LINCOLN/LANCASTER COUNTY PLANNING COMMISSION STAFF REPORT

APPLICATION NUMBER Annexation 19005 Change of Zone 17013A	FINAL ACTION? No (both applications)	DEVELOPER Iron Ridge Development, LLC
PLANNING COMMISSION HEARING DATE January 8, 2020	RELATED APPLICATIONS AN19005 & CZ17013A	LOCATION S. 34 th Street & Rokeby Road

**RECOMMENDATIONS: ANNEXATION 19005 (CONDITIONAL APPROVAL)
CHANGE OF ZONE 17013A (CONDITIONAL APPROVAL)**

Amendment to the
Iron Ridge - Planned
Unit Development

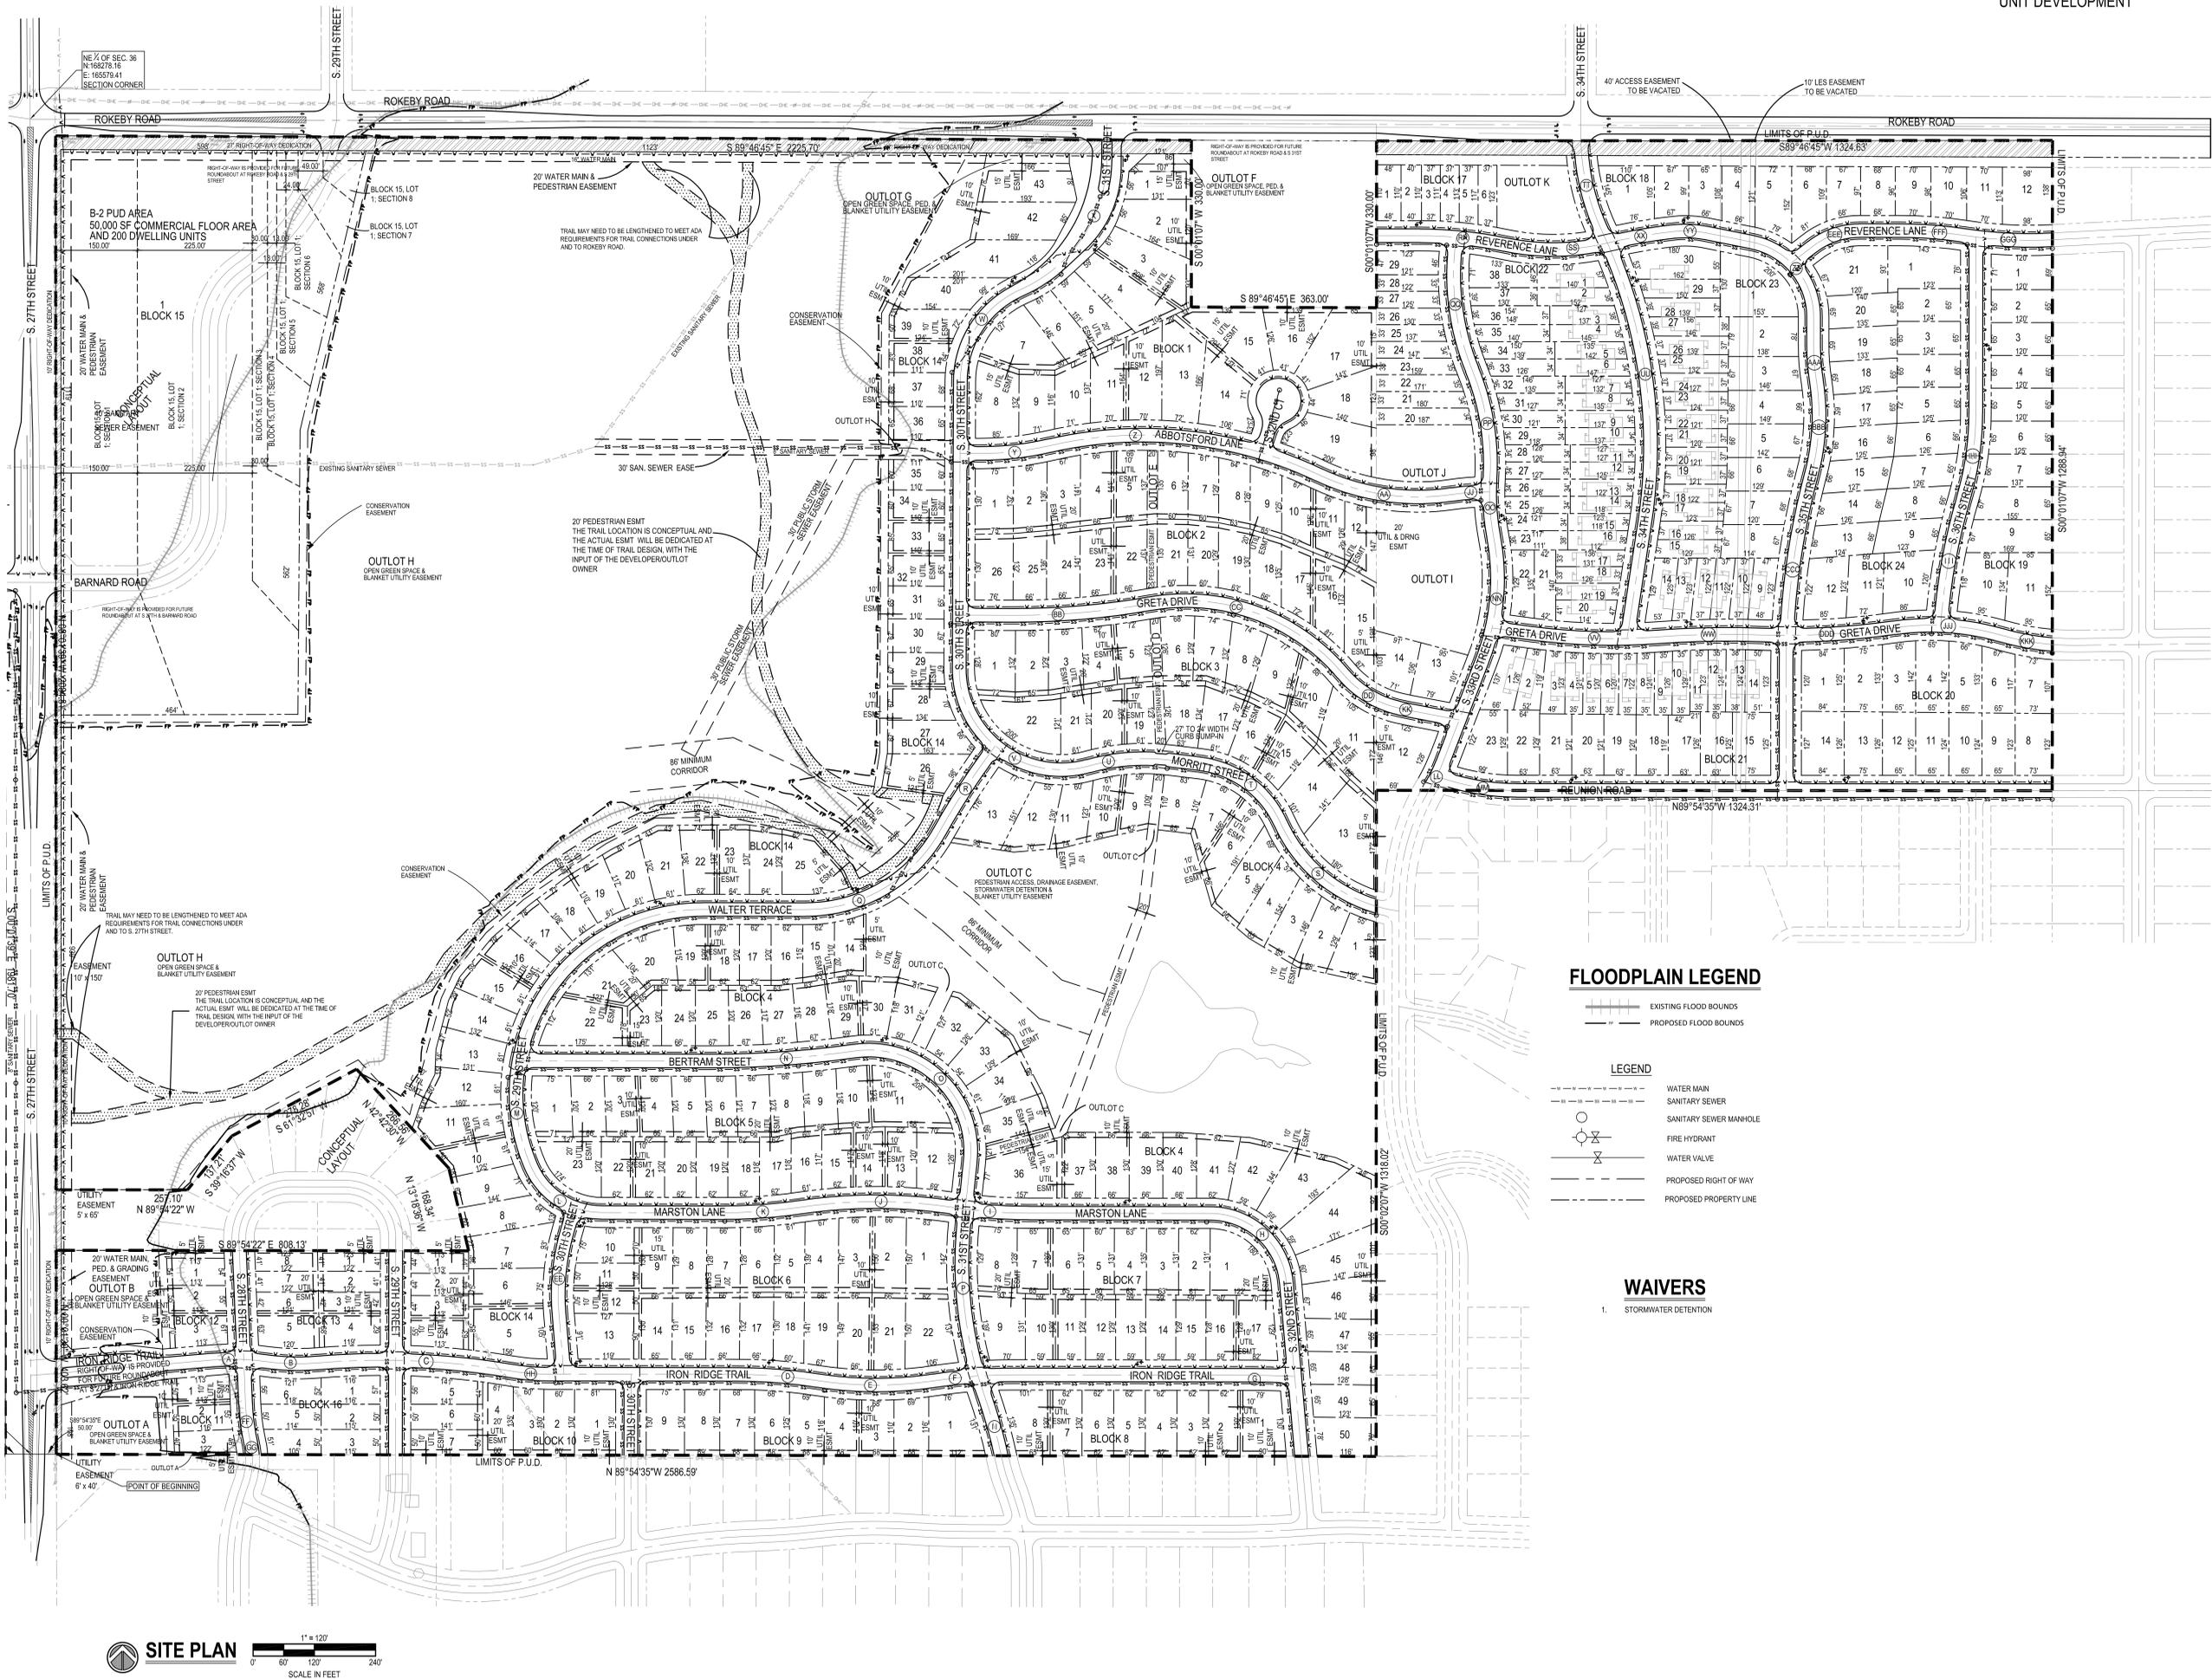
- 3.3 Delete General Note 21.
 - 3.4 Revise the legal description and site plans to the satisfaction of the LTU - Survey Check Department, County Assessor and County Engineer. Update the correct legal description on the site plan.

- 3.13 Delete General Note 25 and provide an exhibit showing compliance with guest parking standards of 27.67.040 (f).
 - 3.14 Provide a summary table for lot counts and the outlots.
